Stage 5: Final Self Governance Modification Report		At what stage is this document in the process?										
<h1 style="color: #00a651;">GC0111:</h1> <h2 style="color: #00a651;">Mod Title: Fast Fault Current Injection specification text</h2>

GC0111 was proposed by Mike Kay on behalf of Electricity North West and was submitted to the Grid Code Review Panel in April 2018. The Panel decided to send the Proposal to a joint Workgroup (with the Distribution Code) to be developed and assessed against the Grid Code Applicable Objectives.

GC0111 aims to update the Grid Code with revised text for fast fault current injection to dispel any confusion in interpretation of the existing text.

Figure ECC.6.3.16(a)

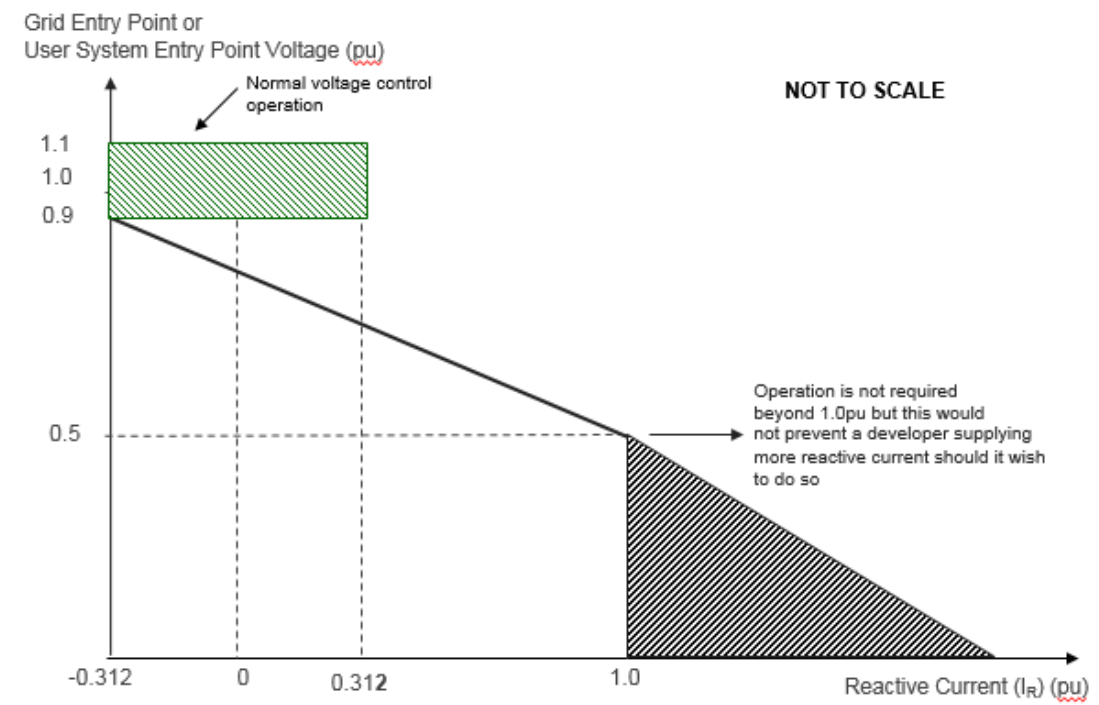
For any balanced ~~or unbalanced~~ fault which results in the positive phase sequence -voltage falling below the voltage levels specified in ECC.6.1.4 phase voltage on one or more phases falling outside the limits specified in ECC.6.1.2 at the **Grid Entry Point** or **User System Entry Point (if Embedded)**, each **Type B, Type C and Type D Power Park Module** or each Power Park Unit within a Type B, Type C and Type D Power Park Module or HVDC Equipment shall, as a minimum (unless an alternative type registered solution has unless otherwise been agreed with The Company), be required to inject a reactive current above the ~~heavy black line shaded area~~ shown in Figure ECC.16.3.16(a) and Figure 16.3.16(b). For the purposes of this requirement, the maximum rated current is taken to be the maximum current each Power Park Module (or constituent **Power Park Unit**) or **HVDC Converter** is capable of supplying when operating at rated **Active Power** and rated **Reactive Power** (as required under ECC.6.3.2) at a nominal voltage of 1.0pu. For example, in the case of a 100MW **Power Park Module** the **Rated Active Power** would be taken as 100MW and the rated **Reactive Power** would be taken as 32.8MVARs (ie **Rated MW** output operating at 0.95 **Power Factor** lead or 0.95 **Power Factor** lag as required under ECC.6.3.2.4). For the avoidance of doubt, where the phase voltage at the **Grid Entry Point** or **User System Entry Point** is not zero, the reactive current injected shall be in proportion to the retained voltage at the **Grid Entry Point** or **User System Entry Point** but shall still be required to remain above the shaded area in Figure 16.3.16(a) and Figure 16.3.16(b).

ECC.6.3.16.1.3 Figure ECC.6.3.16(a) defines the reactive current (I_R) to be supplied under a faulted condition which shall be dependent upon the pre-fault operating condition and the retained voltage at the **Grid Entry Point** or **User System Entry Point** voltage. For the avoidance of doubt, each **Power Park Module** (and any constituent element thereof) or **HVDC Equipment**, shall be required to inject a reactive current (I_R) which shall be not less than its pre-fault reactive current and which shall as a minimum increase with the fall in the retained voltage each time the retained-voltage at the **Grid Entry Point** or **User System Entry Point (if Embedded)** falls below 0.9pu whilst ensuring the overall rating of the **Power Park Module** (or constituent element thereof) or **HVDC Equipment** shall not be exceeded.

Figure ECC.6.3.16(b)

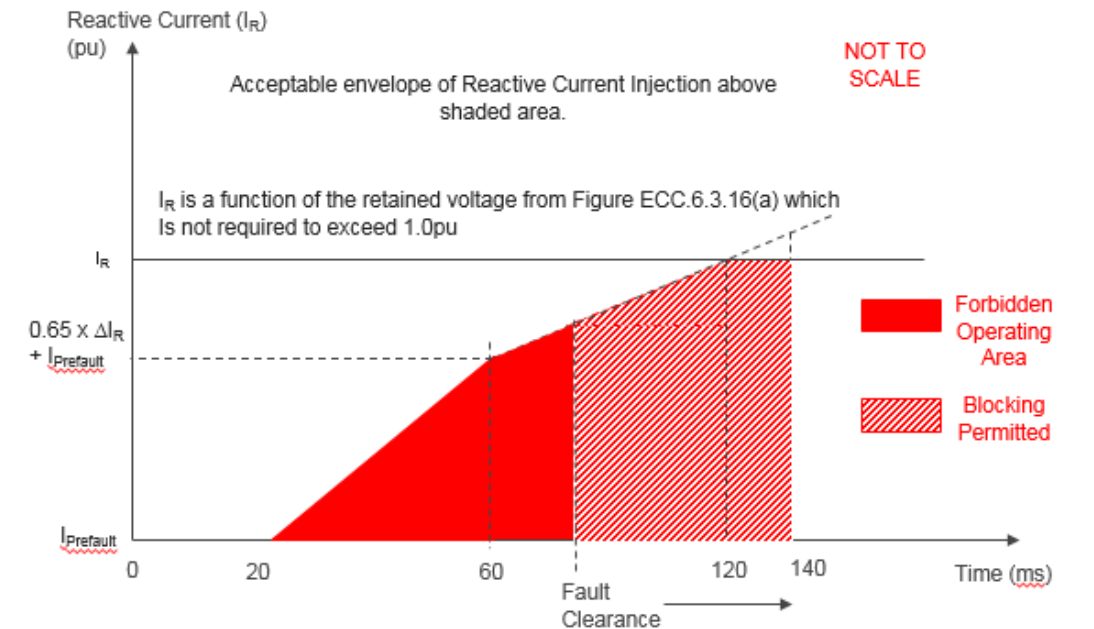
ECC.6.3.16.1.4 In addition to the requirements of ECC.6.3.16.1.2 and ECC.6.3.16.1.3, each **Type B, Type C and Type D Power Park Module** or each **Power Park Unit** within a **Type B, Type C and Type D Power Park Module** or **HVDC Equipment** shall be required to inject reactive current above the shaded area shown in Figure ECC.6.3.16(b) and Figure ECC.6.3.16(c) which illustrates how the reactive current shall be injected over time from fault inception in which the value of I_R is determined from Figure ECC.6.3.16(a). In figures ECC.6.3.16(b) and ECC.6.3.16(c) ΔI_R is the value of the reactive current (I_R) less the pre-fault current. In this context fault inception is taken to be when the voltage at the **Grid Entry Point** or **User System Entry Point** falls below 0.9pu.

ECC.6.3.16.1.5 The injected reactive current (I_R) shall be above the shaded area shown in Figure ECC.6.3.16(b) and Figure ECC.6.3.16(c) with priority being given to reactive current injection with any residual capability being supplied as active current. Under any faulted condition, where the voltage falls outside the limits specified in ECC.6.1.4, there would be no requirement for each **Power Park Module** or constituent **Power Park Unit** or **HVDC Equipment** to exceed its transient or steady state rating of 1.0pu as defined in ECC.6.3.16.1.7.

Figure ECC.A.4.2

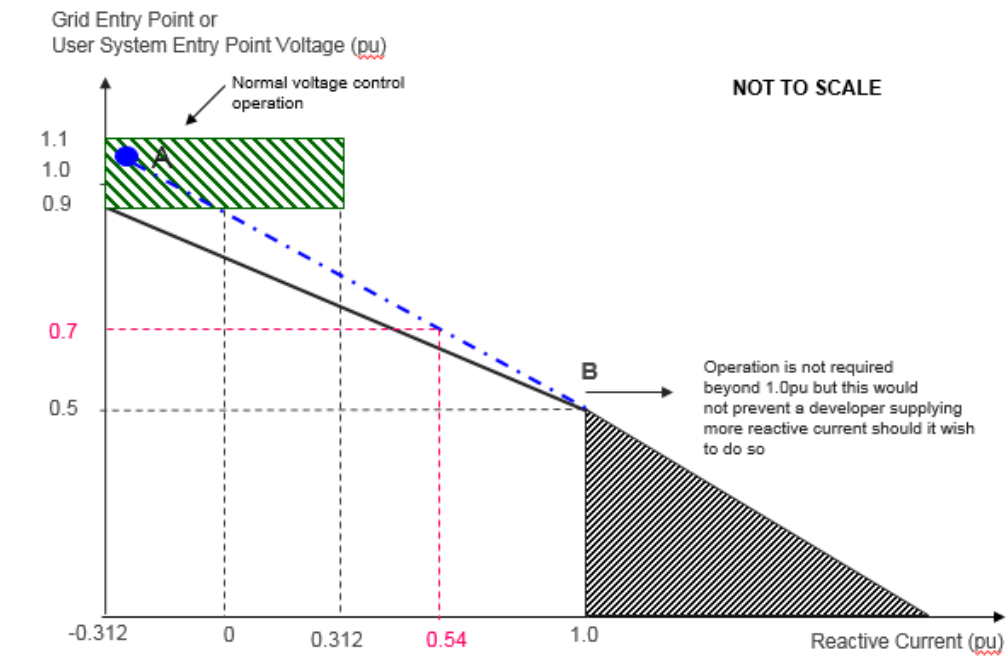
ECC.A.4EC1.4 Figure ECC.A.4.2 is an adaptation of Figure ECC.6.3.16(a) in which the pre-fault operating point is shown by point A in the rectangular shaded area. The trajectory from the initial operating point (point A) to the intersection at 0.5pu voltage and 1.0pu reactive current (point B) is shown by the dashed line. For the purposes of this example it is assumed that the wind farm is exposed to a voltage dip of 0.7 pu at the **Grid Entry Point**. At 0.7pu voltage this intersects line AB giving a reactive current injection of 0.54 pu reactive current which requires the **Power Park Module** to supply a reactive current (I_R) of 0.54pu or greater with any residual current being supplied as active current.

Figure ECC.A.4.5

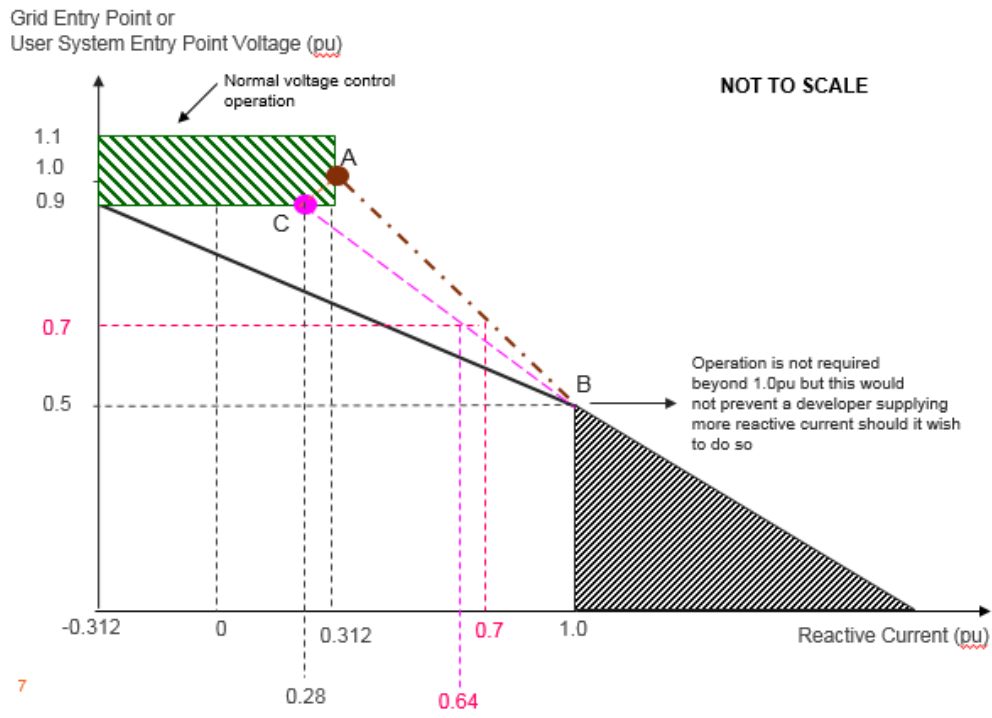
ECC.A.4EC1.6 In the second example, Figure ECC.A.4.5 is an adaptation of Figure ECC.6.3.16(a) in which the wind farm is now operating in the lagging mode of operation. The wind farm is operating at a **Grid Entry Point** voltage of 0.96pu voltage and a reactive current (I_R) of 0.312 pu export. The prefault operating point is shown by point A in the rectangular shaded area. The trajectory from the initial operating point (point A) to the intersection at 0.5pu voltage and 1.0pu reactive current (point B) is shown by the dashed line. For the purposes of this example it is again assumed that the wind farm is exposed to a voltage dip of 0.7 pu at the **Grid Entry Point**. At 0.7pu voltage this intersects line AB giving a reactive current injection of 0.7 pu reactive current. However it is important to recall that the rating of the wind farm should not be exceeded which is shown by revised line CB shown in Figure ECC.A.4.5. The effect of this is important as it means that the reactive current (I_R) supplied should be reduced from 0.7pu to 0.64pu.

Figure ECC4.4(a)

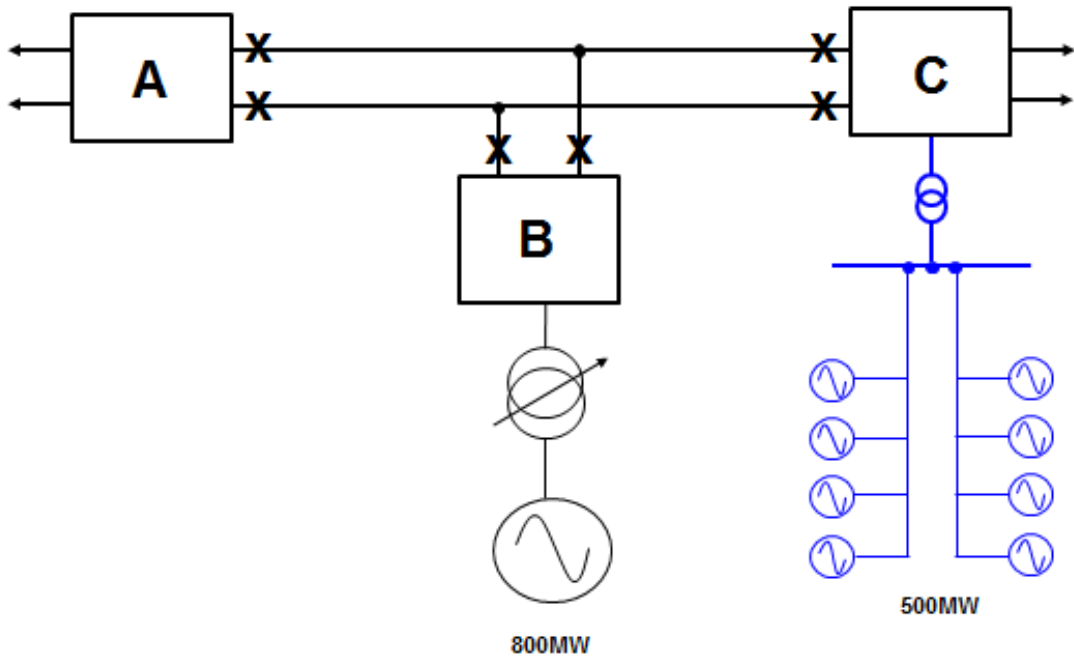
ECC.4EC1.2.1 Under the fault ride through requirements specified in ECC.6.3.15.9 (*Voltage dips cleared in excess of 140ms*), **Type B, Type C and Type D Power Park Modules** are also required to remain connected and stable for voltage dips on the **Transmission System** in excess of 140ms. Figure ECC4.4 (a) shows an example of a 500MW **Power Park Module** connected to the **Transmission System** and Figure ECC4.4 (b) shows the corresponding voltage dip seen at the **Grid Entry Point** or **User System Point** which has resulted from a remote fault on the **Transmission System** cleared in a backup operating time of 710ms.
